Master Plan Amendment #2020-00006
CDD Concept Plan Amendment #2020 -00005
Development Special Use Permit #2019 -00017
TMP Special Use Permit #2021 -00005
Upland Park – 5165 Seminary Road

Application	General Data	
Project Name: Upland Park	PC Hearing:	March 2, 2021
	CC Hearing:	March 13, 2021
	If approved, DSUP Expiration:	March 13, 2024 ¹
	Plan Acreage:	9.82 acres (427,777 SF)
Location: 5165 Seminary Road, multiple addresses	Zone:	CDD #21/Coordinated Development District #21
	Proposed Use:	Residential, Park
	Dwelling Units:	92
	Gross Floor Area:	235,520 SF
Applicant: Alexandria Development Associates, LLC., represented by Ken Wire, attorney	Small Area Plan:	Beauregard Small Area Plan
	Green Building:	Compliance with City's 2019 Green Building Policy

Purpose of Application
Consideration of requests to construct 92 townhomes, public and private streets, streetscape improvements, and a .85 ac (2,500 SF) park.
Special Use Permits and Modifications Requested:
<ol style="list-style-type: none">1. Master Plan Amendment to the Beauregard Small Area Plan Chapter to amend the framework streets map;2. An amendment to previously approved Coordinated Development District #21 Conceptual Design

Figure 15: Framework Streets as adopted

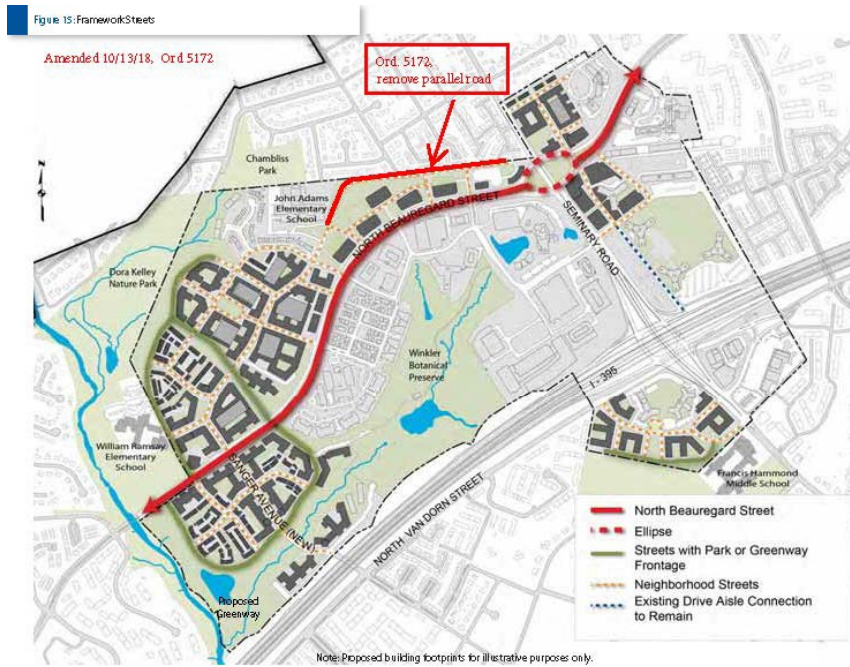
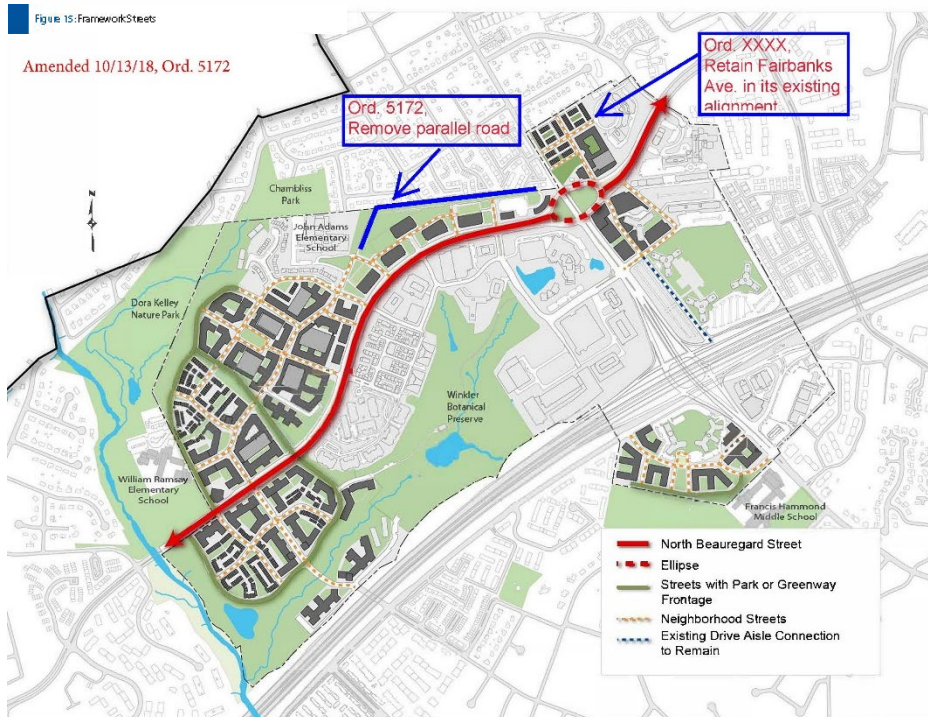
The Upland Park application proposes to amend governing exhibit Figure 15 of the Beauregard Small Area Plan, depicting plan framework streets. The Plan originally envisioned larger development blocks along Seminary Road, with townhouses located along the west side of a relocated Fairbanks Avenue. These were intended to provide a transition between the multi-family structures and single-family homes that front on Echols Avenue to the west.

The applicant's proposal expanded that the single row of townhomes to a three-block neighborhood and maintains Fairbanks Avenue in its current location. As discussed in greater detail in the Site Plan and Transportation sections, staff supports the proposed amendment to Figure 15: Framework Streets, and the retention of the street location. The amended figure also includes the addition of the new one-way street to create visibility along the park edge, and to serve as an additional entry point to the Upland Park neighborhood.
